UNITED STATES
NUCLEAR REGULATORY COMMISSION
WASHINGTON, D. C. 20555

PRELIMINARY REPORT
RELATED TO THE RESTART AND CONTINUED OPERATION OF
FORT ST. VRAIN NUCLEAR GENERATING STATION

Docket No. 50-267

Public Service Company of Colorado

FIGURE 2 Control Rod Drive Brake

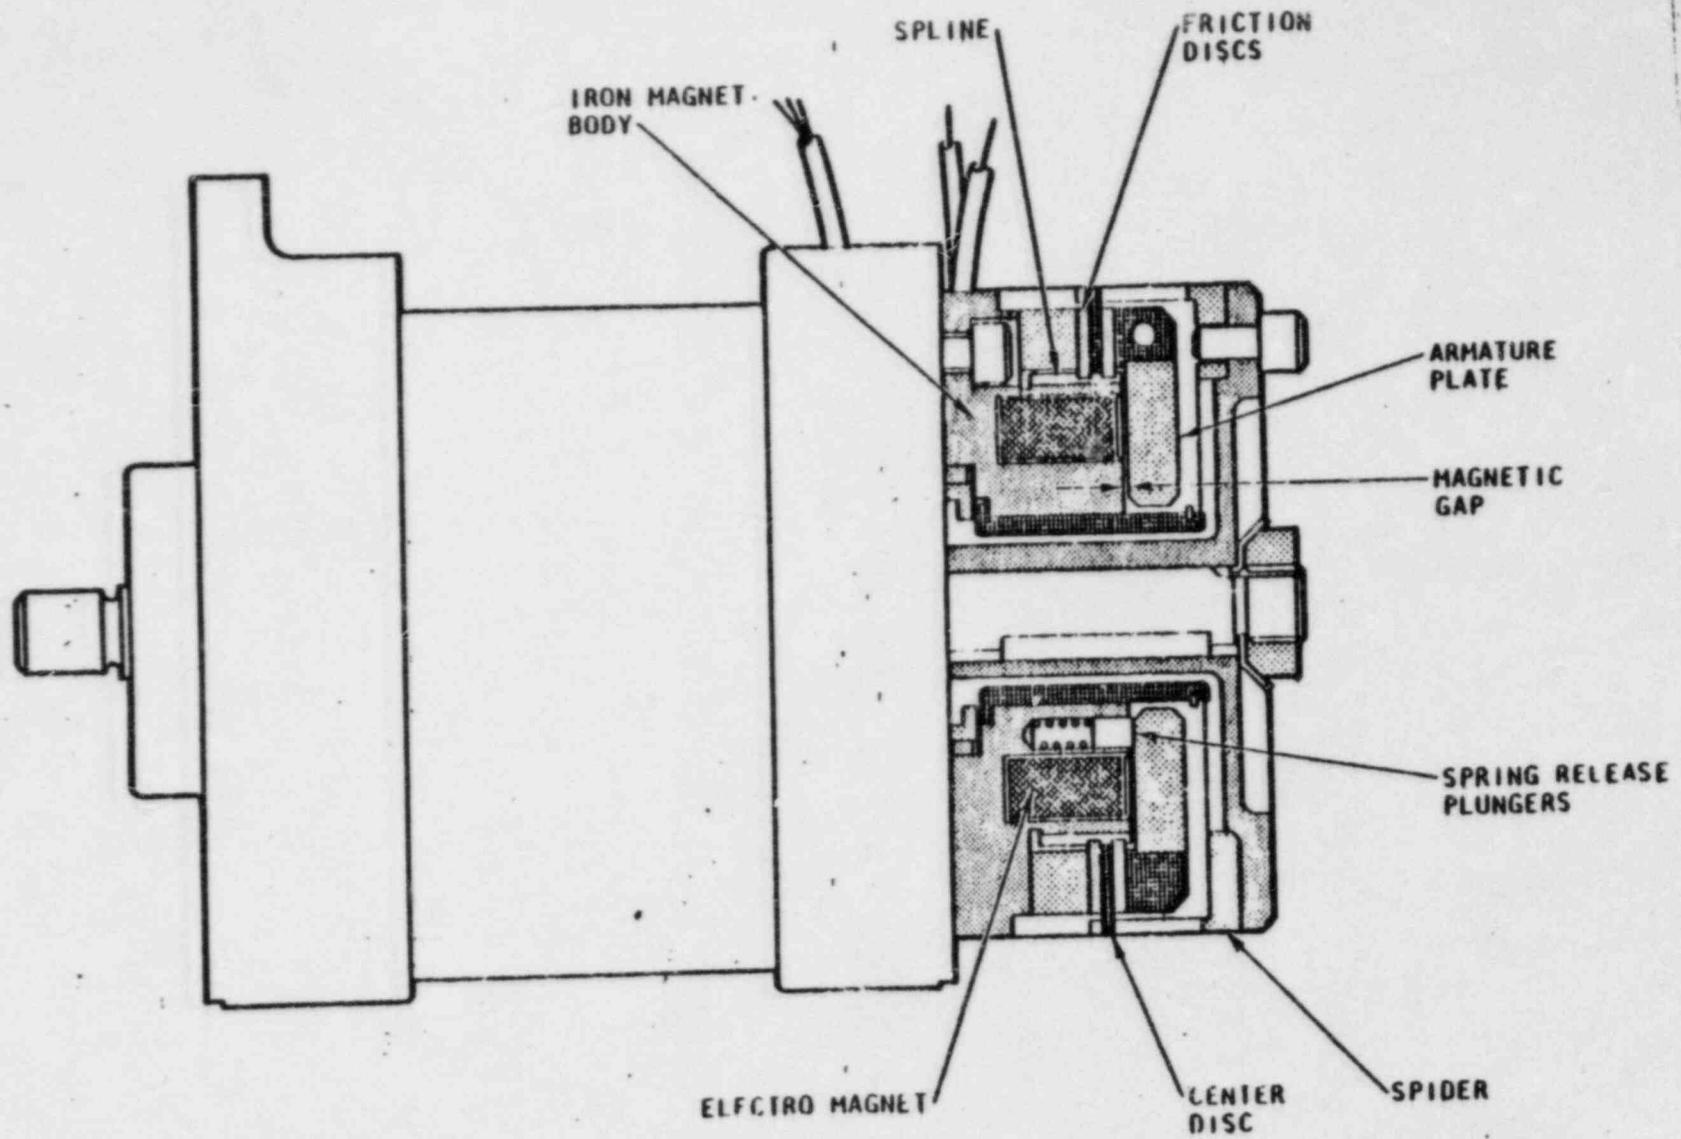
The CRDM functions are dependent on the operation of the motor/brake assembly and the reduction gear train assembly that actually rotates the cable drum. The brake, a modified Bendix multiple-disk EFL model, is shown in Figure 2 energized and engaged, as it would be in retaining the control rod pair in a stationary position. The energized electromagnet draws the armature plate toward the magnet body, thereby clamping the friction disk, which is constrained from rotation by the spline on the magnet body. The friction disk is keyed by three slots that engage with the arms of the spider, which is keyed to the rotor shaft through the motor drive. When the electromagnet is deenergized, spring plungers push the armature plate away from the magnet body, disengaging the brake and allowing the friction disk, spider, and rotor shaft to rotate freely as the control rods enter the core by gravity.

FIGURE 3 MOTOR & BRAKE ASS'Y

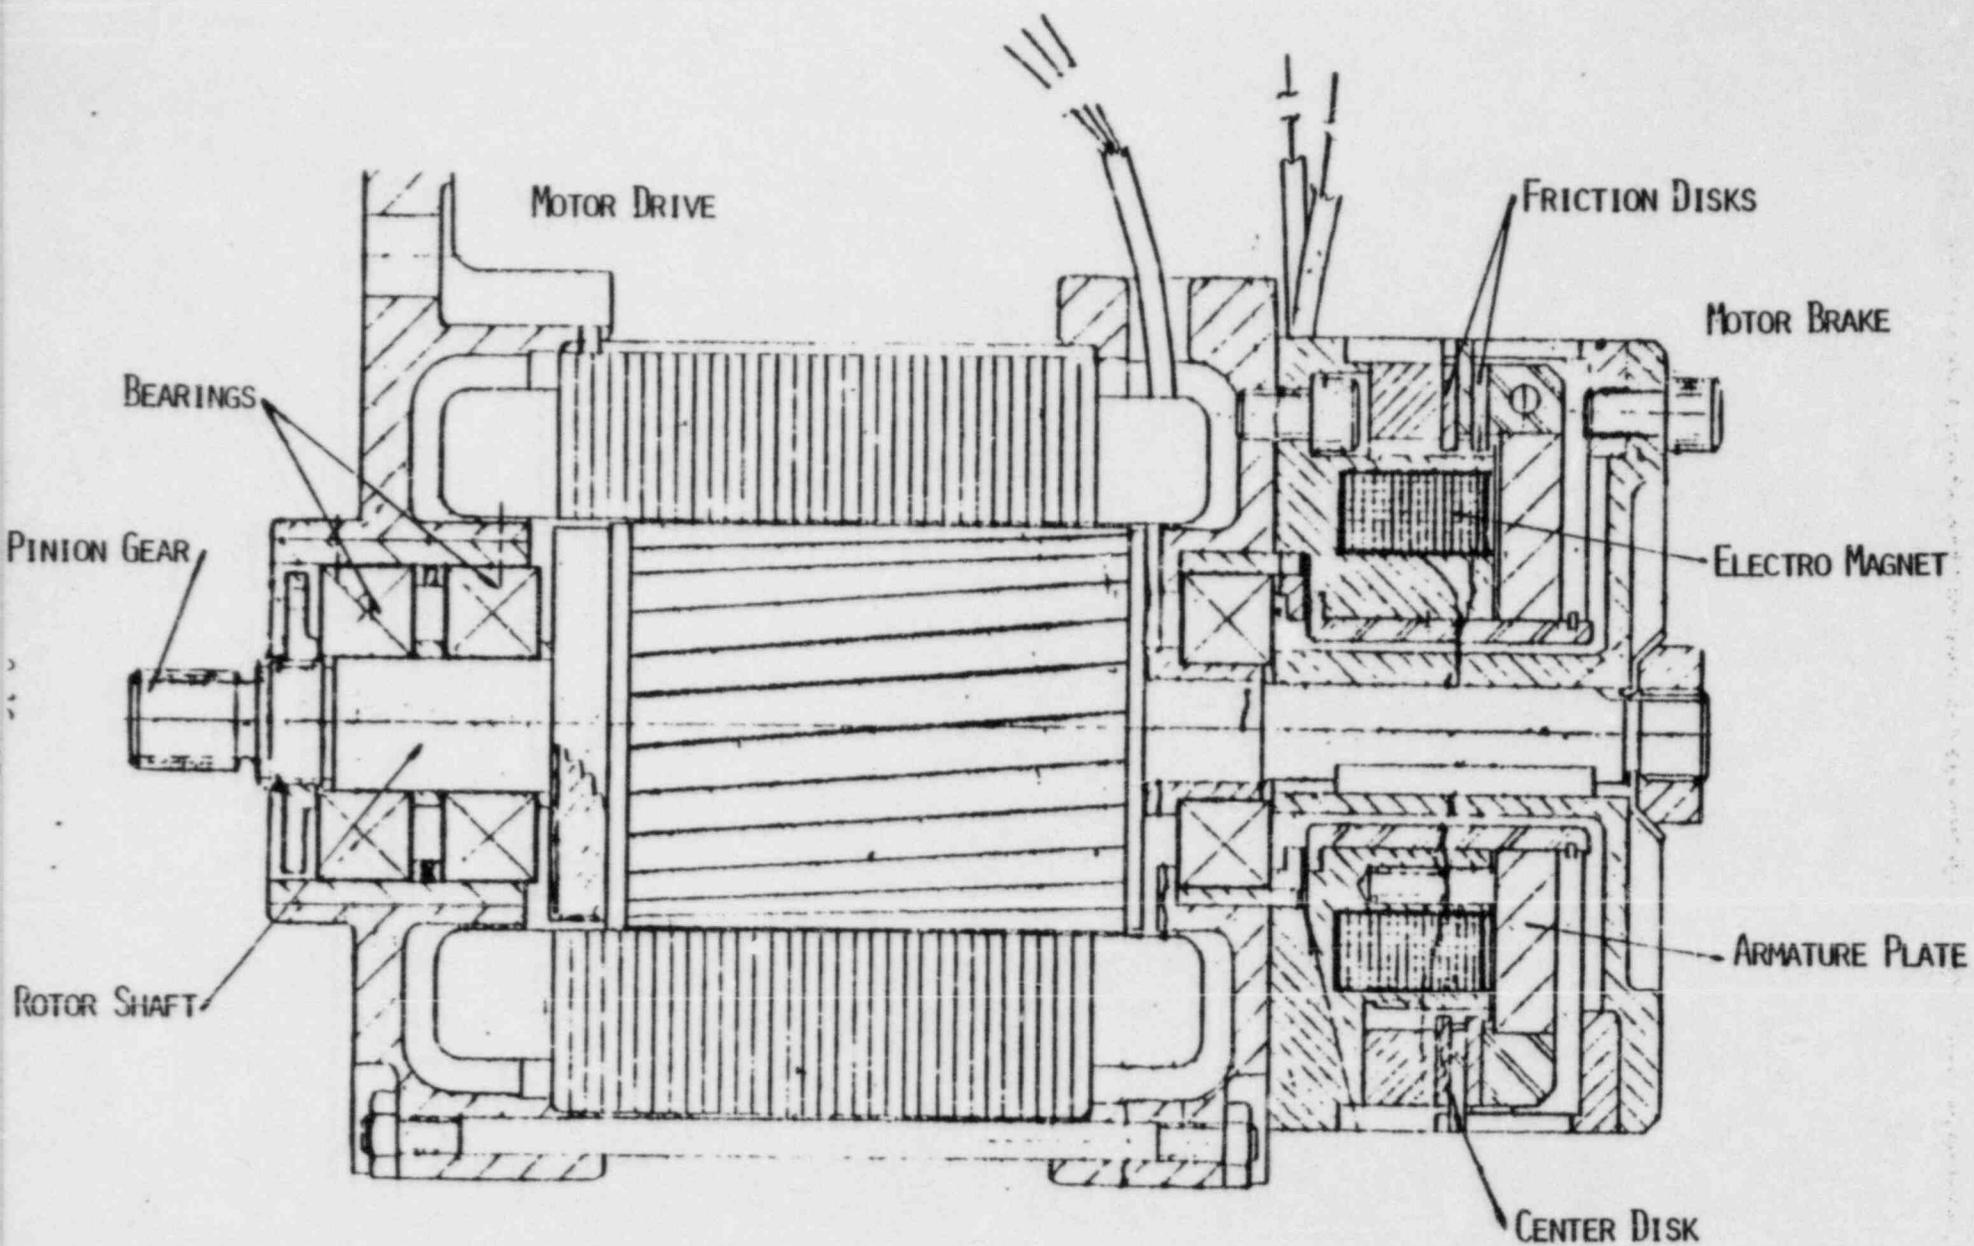
Figure 3 shows the relation between the motor brake and drive motor assembly. The drive motor is a three-phase, four-pole induction motor. The rotor shaft through the motor connects the brake assembly on one end with the pinion gear and reduction gear train on the other end. Normally, the motor is energized only to move the control rods in or out of the core and is deenergized while the brake is engaged.

3.1
Fig. Control rod drive mechanism (rear view)

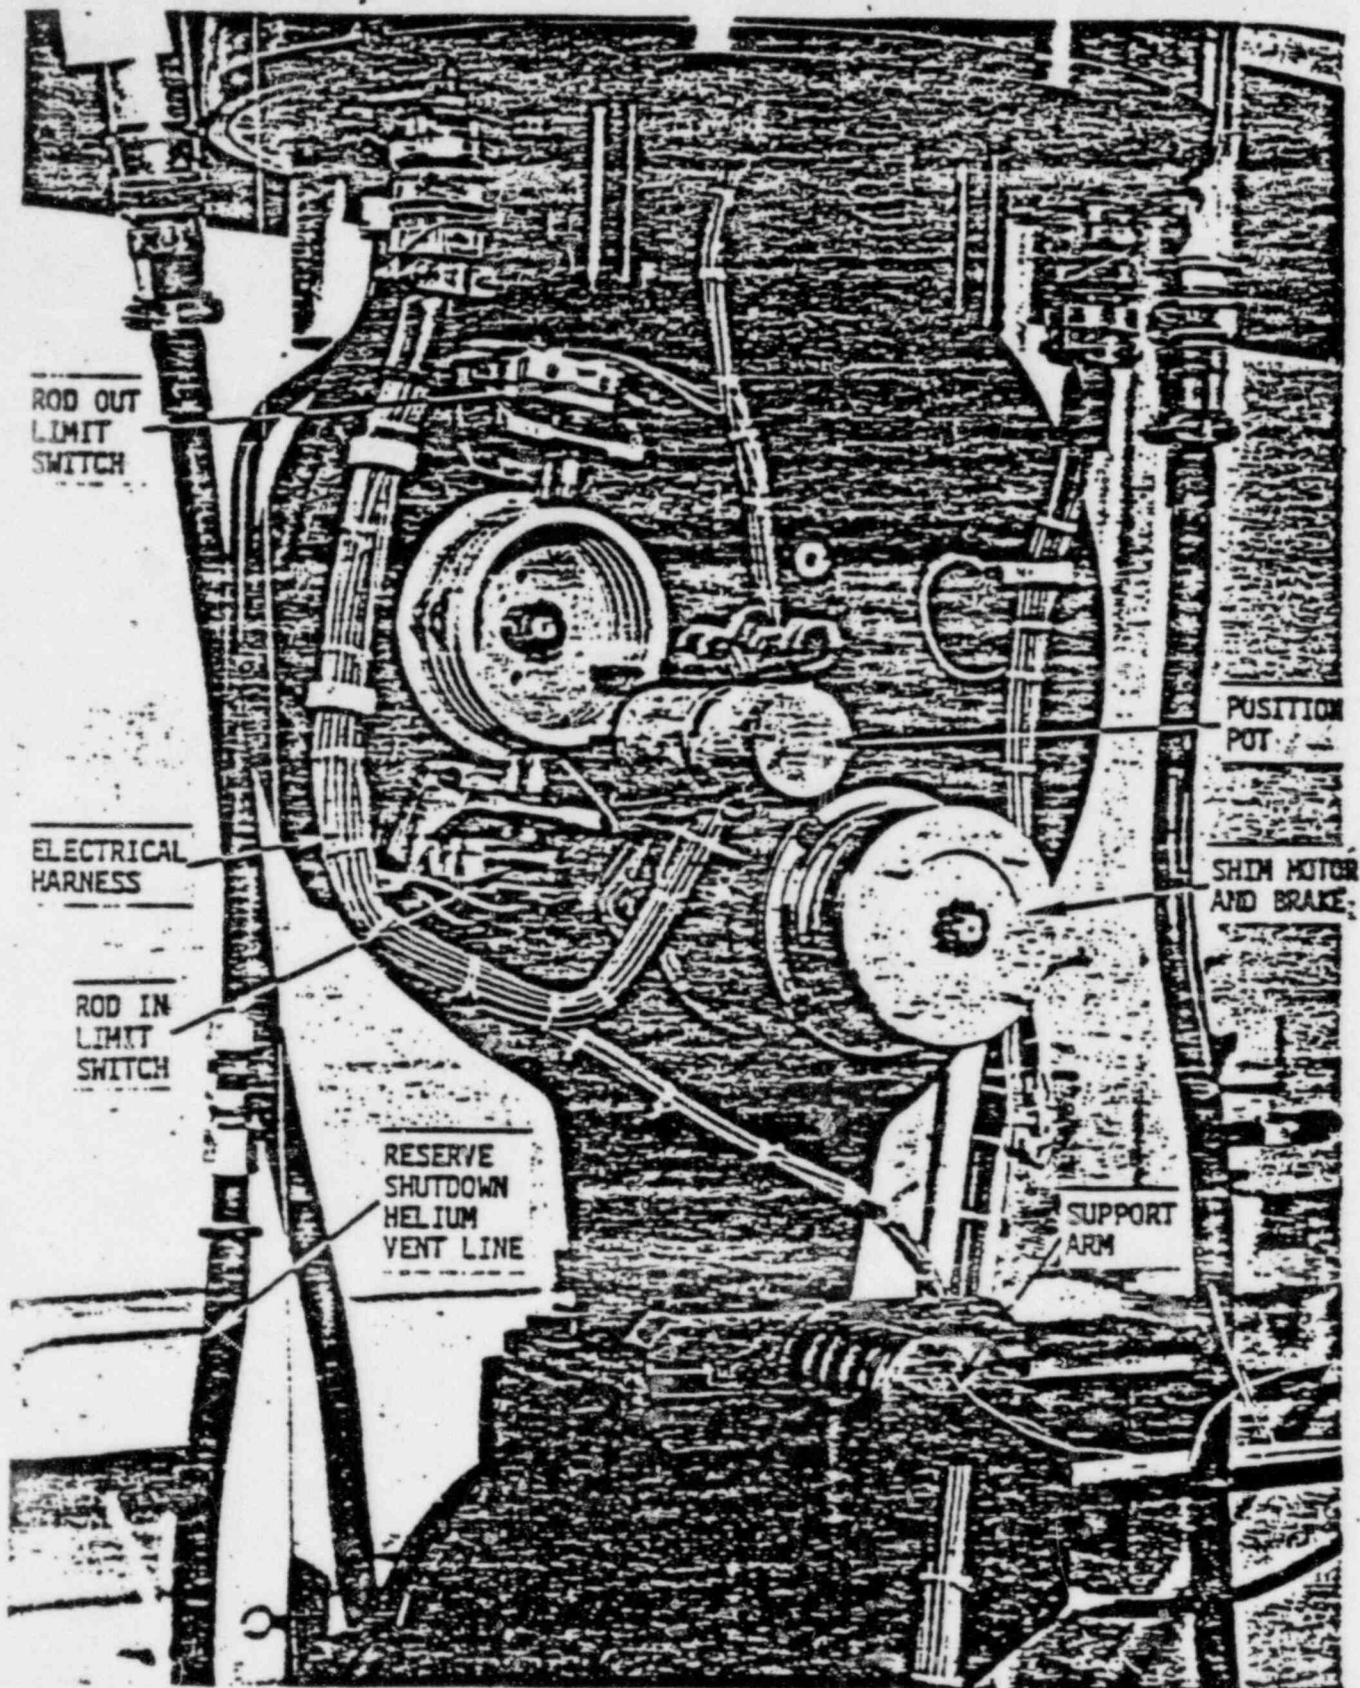
As described in Section 2 of this report, the principal mechanical components of the CRDM are the shim motor and motor brake assembly, the reduction gearing to the cable drum, and the control rod pair suspended by cables from the drum. Integrated into the CRDM and used to determine control rod positions are the instrumentation-related components that include the rod position potentiometers, rod-in and rod-out limit switches, limit switch cams and gear reducer, and the slack-cable indication device. The relative locations of these components are shown on Figure 3.1.

Fig. 3.2 Section BB of Drawing D-1201-200, Control Rod Assembly.

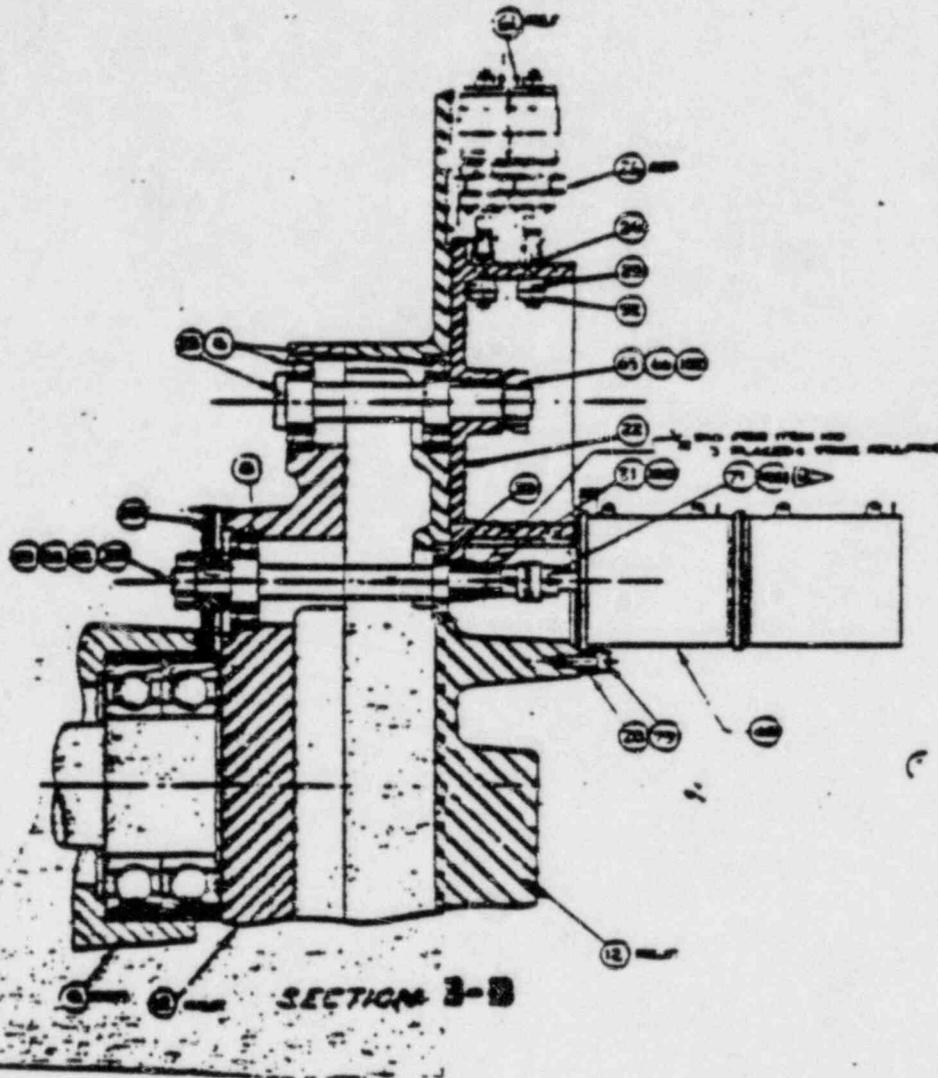
- d. Investigate a design change to provide a positive stop on the CRDM position indicator potentiometer shaft to prevent overtravel (Section 3) and provide the results to the NRC.

The control rod potentiometers are intended to provide continuous monitoring of control rod position. As shown in Figure 3.2, both of the ten-turn, potentiometers are directly coupled to the rotation of the cable drum. The

As previously mentioned, "rod-in" and "rod-out" position indication is provided by cam-actuated limit switches (the potentiometer shaft shown in Figure 3.2 also drives the cam wheel). At the full rod-in position, the cable anchor on the cable drum and the cam are at the 6 o'clock position, and both rod-in limit switches are actuated. Full rod travel (190 ± 1 inches) to the rod-out position causes the cam wheel to rotate clockwise $3/4$ turn, actuating the pair of rod-out limit switches. Limit switch actuation is indicated by steadily-lighted lamps in the control room.
